NO. DATE BY REVISION STATE OF WISCONSIN
DEPARTMENT OF TRANSPORTATION STRUCTURE B-40-285-27G

1228-21-71

GENERAL NOTES AND QUANTITIES

SHEET 2 OF 5

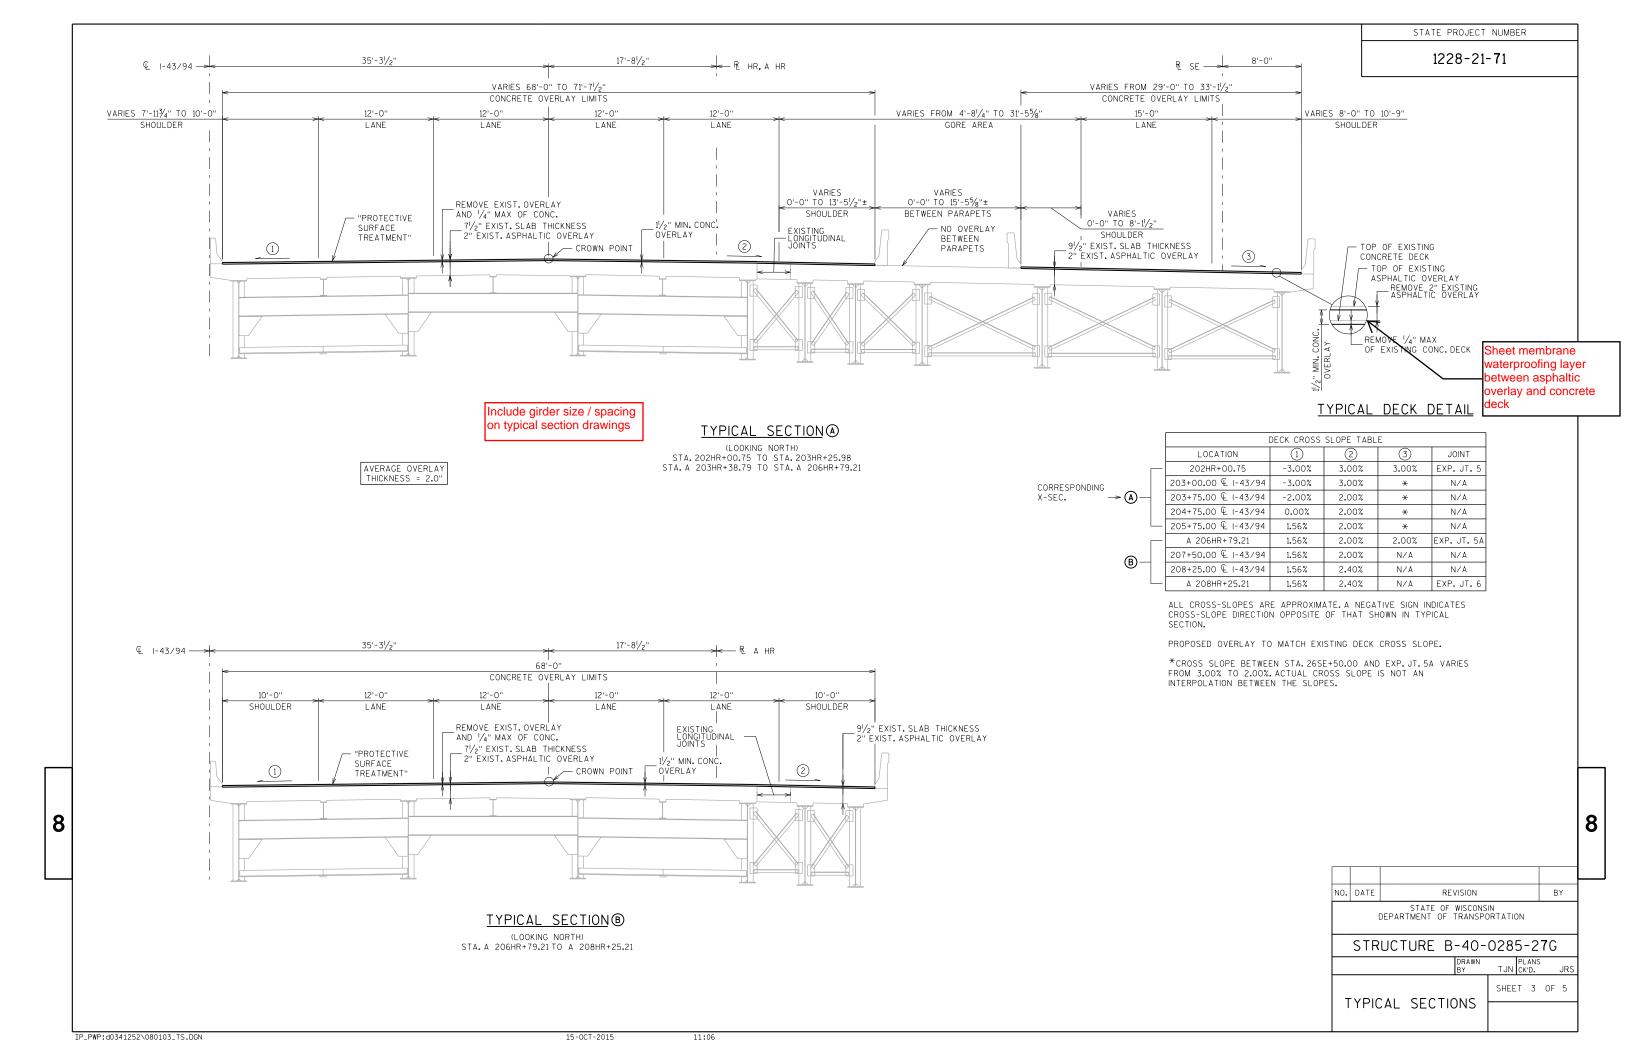
low long after overlay is

Note not required if existing

proposed work

name plate is not impacted by

laced is the contractor

esponsible for sealing

racks?

Does bid item include removal of 1/4" of concrete n addition to asphalt? If not include "cleaning decks" bic tem as well.

f deck surface preparation is included in "removing asphaltic concrete overlay special", include general note stating that that is the case
